Pre-Design Phase
Pinnacle Peak Road and Channel
99th Avenue to the Agua Fria River

Flood Control District of Maricopa County
Phoenix, Arizona

Value Analysis Final Report

November 2, 2009

Sketch Worksheet

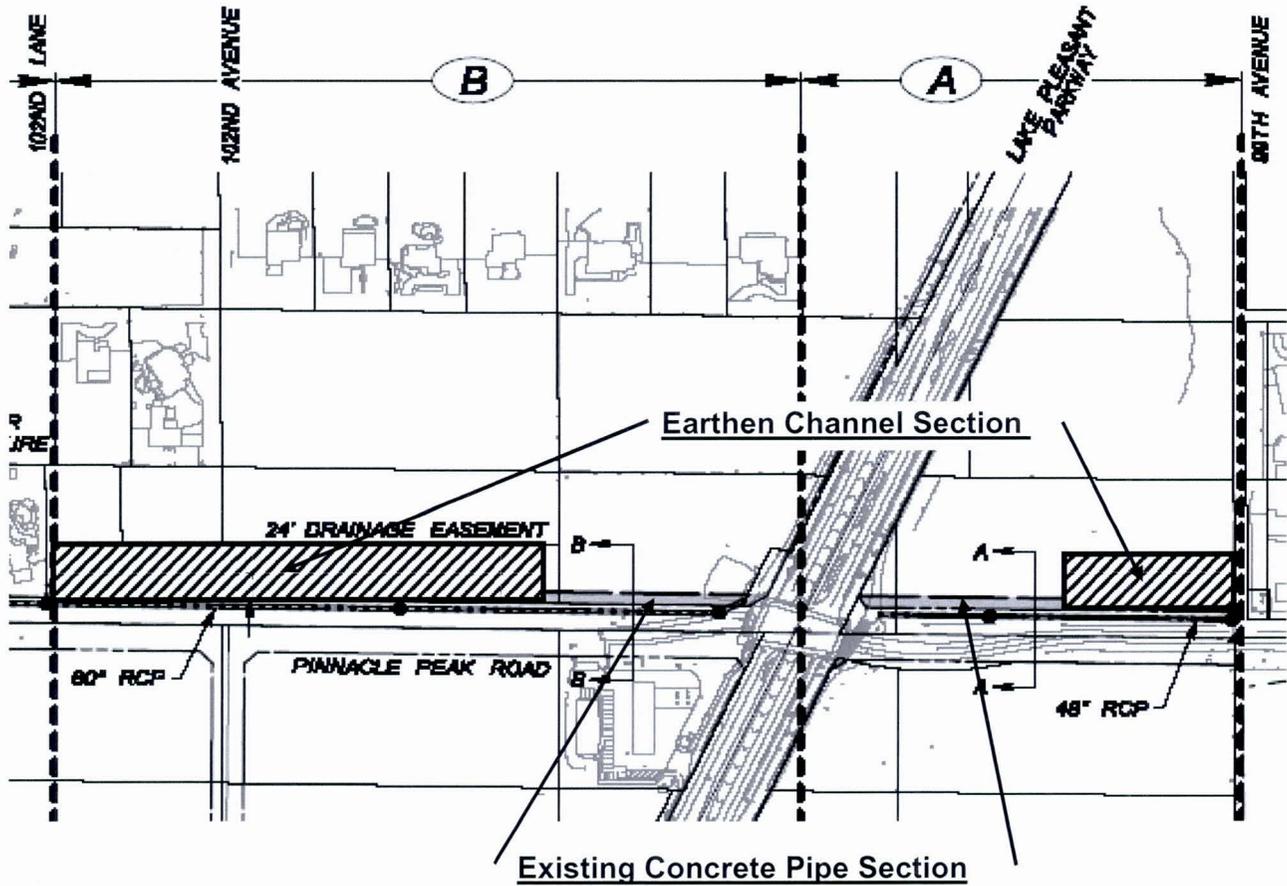
Item: Replace pipe with channel in Segments A & B except at high cost R.O.W areas

Segments A & B are closed conduit (concrete pipe) with 55 ft. road right of way and 24 ft. drainage easement to collect flows

Within high cost right of way areas (adjacent to Lake Pleasant Parkway), design is to stay the same. Outside of the high cost of right of way areas, design is to be earthen channel (55 ft. ROW + 90 ft. ROW)

- More open space & opportunity for habitat
- Improved trail connectivity
- Easier to collect overland flows
- Improved operation & maintenance (sediment less of an issue)
- Access to irrigation system for landscaping

- Future crossings will be needed
- Operation & maintenance costs could be higher
- Depth of box at Lake Pleasant Parkway could require low flow

Additional savings can be realized by downsizing upstream end of channel

Sketch Worksheet

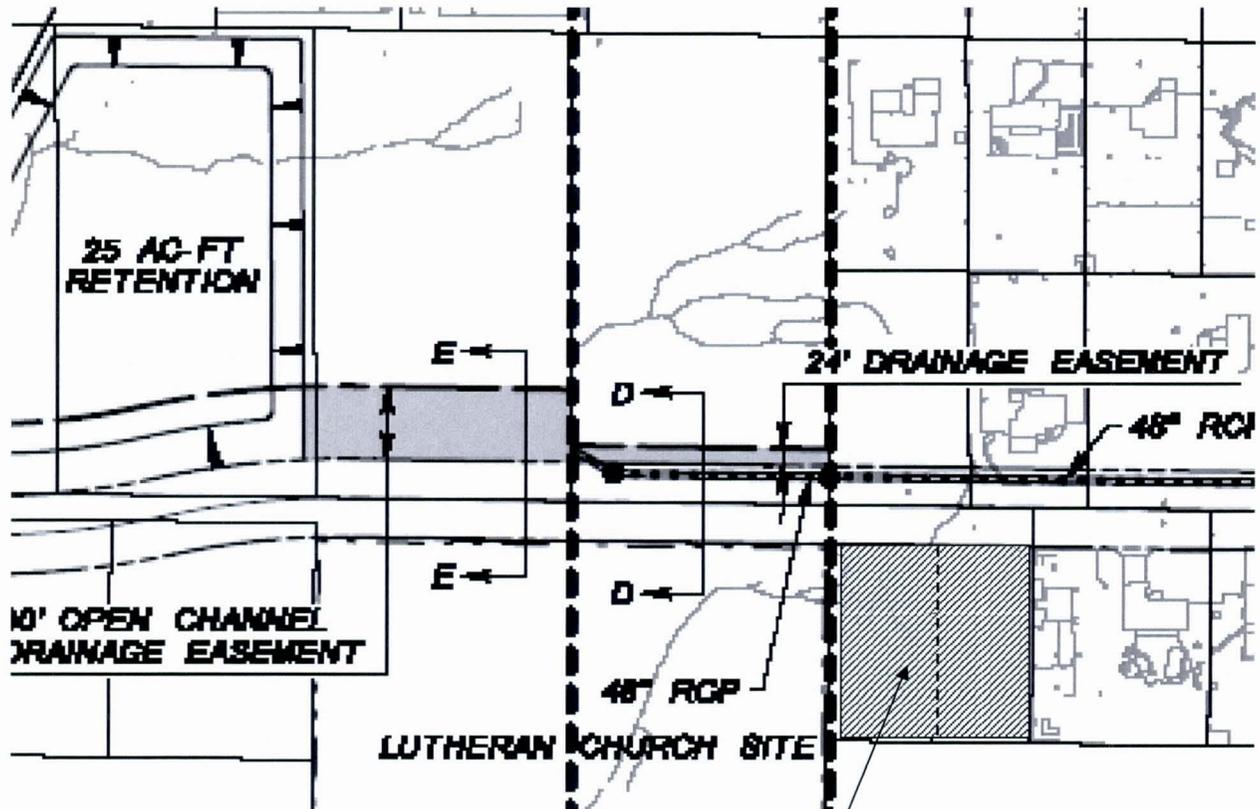
48" RCP storm drain pipe conveying flow downhill approximately 20 ft. to the open channel.

Use existing property easements at the hill for a series of drop structures to convey and dissipate the flows going down the hill to the open channel.

- Solves problem of energy dissipation at bottom of hill
- Takes advantage of easements already in place

- Additional cost to add aesthetic treatment to drop structure

Item: Use existing easements at hill for possible drop structures in lieu of pipe

Existing property easements
Potential location for
drop structure

Sketch Worksheet

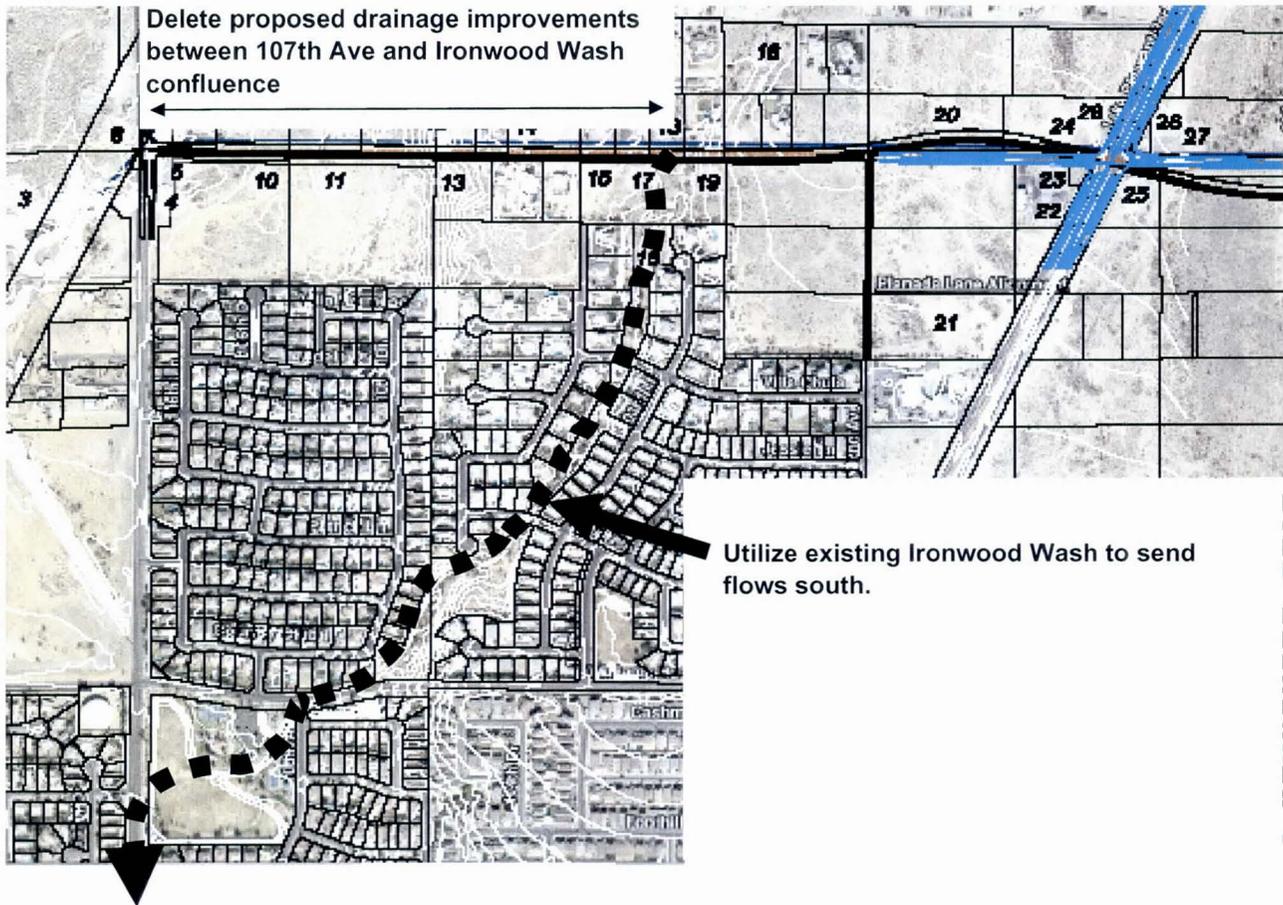
Recommended alternative Option 5 drainage pipe, basins and channel along Pinnacle Peak Parkway from Lake Pleasant Parkway to 107th Avenue.

Delete all proposed drainage improvements identified in Option 5 from 107th Ave. east to the existing Ironwood Wash. Improve conveyance capacity of existing channel along 107th Ave. and / or increase size of existing Williams Park & Rose Garden Lane basins.

- Eliminates flooding of 107th Ave. between Williams Drive & Deer Valley
- Utilizes existing capacity of the Ironwood Channel and Williams Park basin
- Reduces amount of flood control infrastructure

- Does not decrease the flow at Williams Park basin
- Traffic management issue at 107th Ave. during construction

Existing Ironwood Wash has the ability to handle in excess of 400 CFS. Assumes installation of drain pipe within existing ROW.

Item: Send flows south through Ironwood Wash in lieu of drainage improvements

Improve conveyance capacity of existing system south along 107th Ave. to alleviate existing street flooding. Possibly add a segment of storm drain and / or increase size of existing Williams Park & Rose Garden Lane basins.

Sketch Worksheet

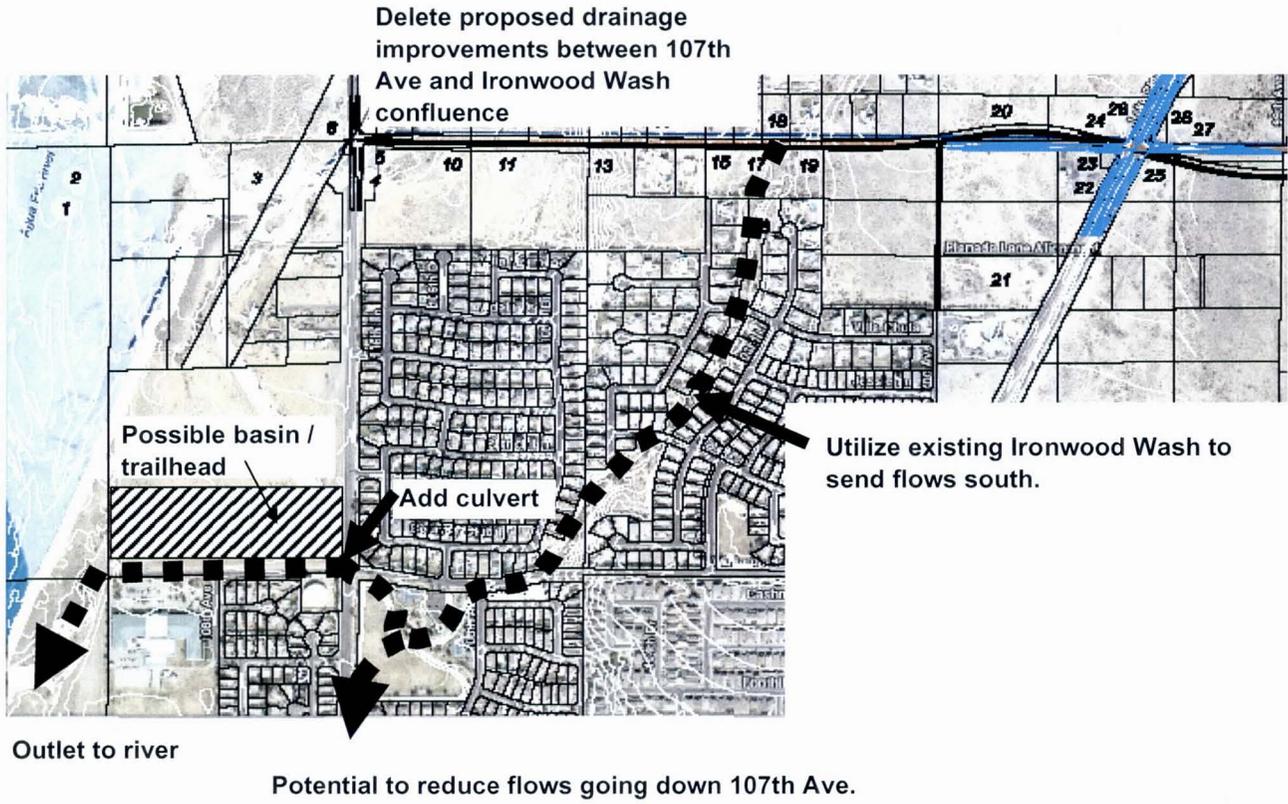
Recommended alternative Option 5 drainage pipe, basins and channel along Pinnacle Peak Parkway from Lake Pleasant Parkway to 107th Avenue.

Delete all proposed drainage improvements identified in Option 5 from 107th Ave. east to the existing Ironwood Wash. Add a control to reduce flows south out of the Williams Park basin to reduce flooding on 107th Ave. Add a culvert to the northwest under the intersection of Williams Drive and 107th Ave. leading to a proposed channel and / or basin leading to the Agua Fria River. (see VA # 51)

- Eliminates flooding of 107th Ave. between Williams Road & Deer Valley
- Utilizes existing capacity of the Ironwood Channel and Williams Park basin
- Reduces amount of new flood control infrastructure
- Better location for potential multi-use opportunities
- Bypasses sand & gravel operations for outlet to river

- Does not decrease the flow at Williams Park basin
- Need to acquire state land north of Williams Road
- May be utility conflicts with new culvert at Williams Road & 107th Ave.

Potential for equestrian trailhead north of Williams Road allowing access to river without equestrian crossing of 107th Ave.

Item: Construct channel and basin along Williams from 107th to Agua Fria River

Sketch Worksheet

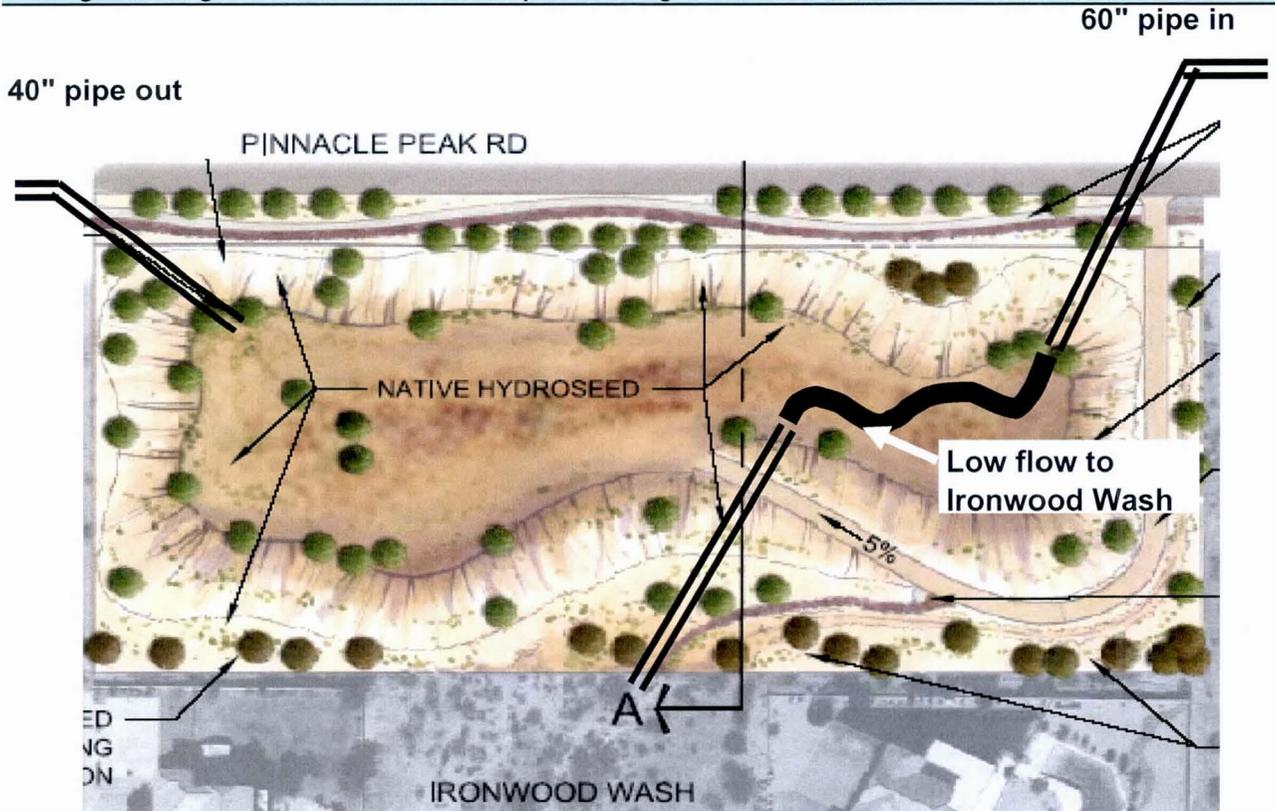
Segment C design with 42" RCP, splitter structure and a 15 acre-ft surge (off line) basin

Delete splitter structure and 42" RCP adjacent to basin. Use basin as an in-line basin. Direct low flow to Ironwood Wash.

- Reduces amount of 42" pipe
- Improves hydraulics

- More frequent maintenance due to water in the channel

Item: Eliminate splitter structure & pipe (north of basin) and make an in-line basin with low flow

Sketch Worksheet

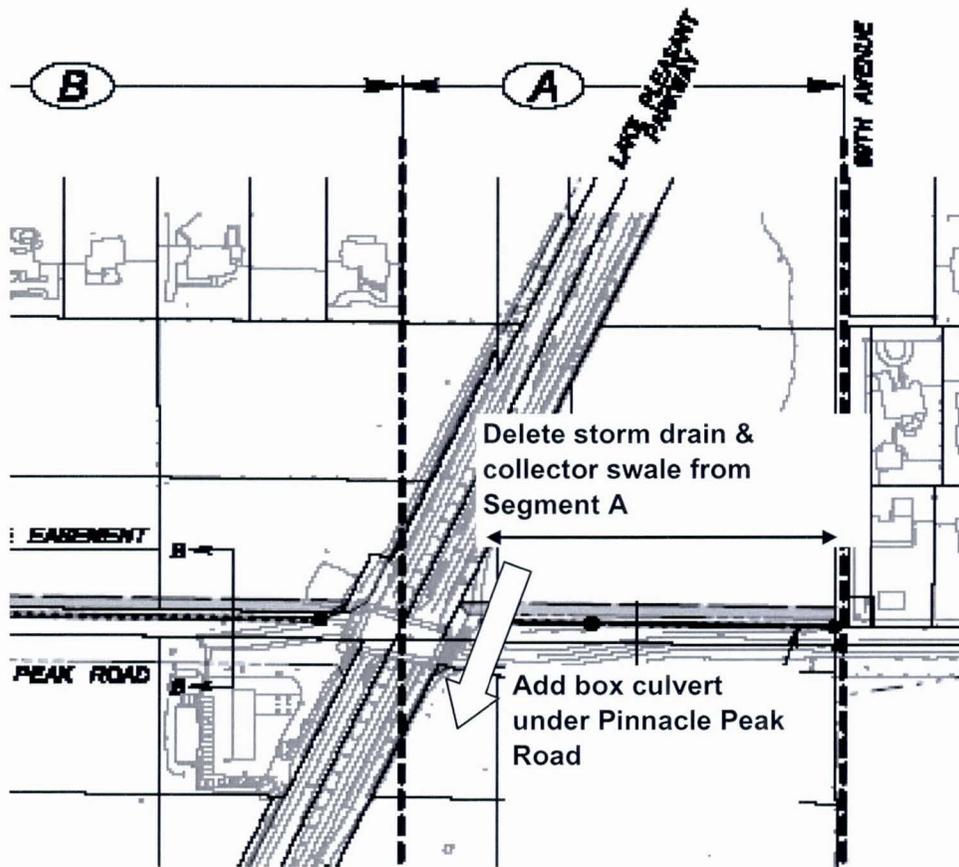
Recommended Alternative Option 5 indicates 48" RCP pipe and collector swale from east of Lake Pleasant Parkway to 99th Ave.

Do not allow any flows east of Lake Pleasant Parkway into the proposed drainage system. Drain flow at NE intersection of Lake Pleasant Road & Pinnacle Peak south through a culvert. Reduce storm drain size in Segment B and C from 60" to 48".

- Reduce the size of storm drain of Lake Pleasant Parkway in Segments B & C

- Does not address drainage problems on Lake Pleasant Road south of Pinnacle Peak

No sacrifice in performance compared with the current condition. Interim reduction in performance

Item: Consider draining Segment A to the east or south

Sketch Worksheet

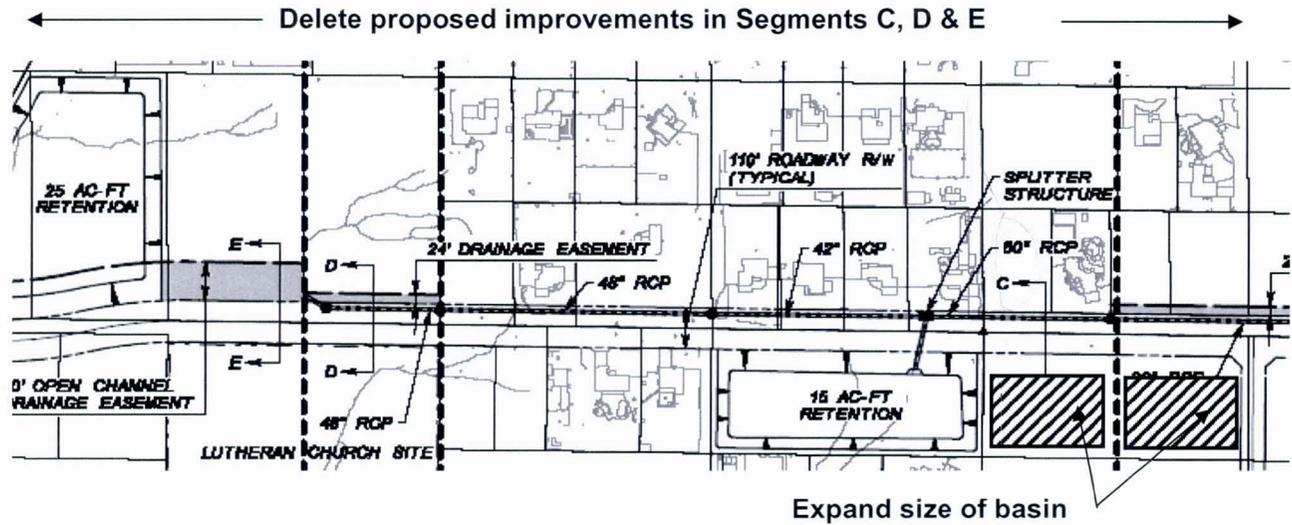
Recommended Alternative Option 5 with 15 acre ft. retention basin at the south side of Pinnacle Peak Road between 103rd & 104th Avenues.

Expand the size of the basin to the east to accommodate the total upstream flow of the system thereby eliminating all the proposed improvements west of 104th Avenue. Existing rising grades between 102nd & 103rd Avenues may necessitate multiple basins at different elevations.

- Cheaper land acquisition for basin
- Concentrates open space

- Difficult to configure such that all the storage volume can be utilized

Item: Expand Basin C-S (south of Pinnacle Peak Road) to the east to attenuate additional flows
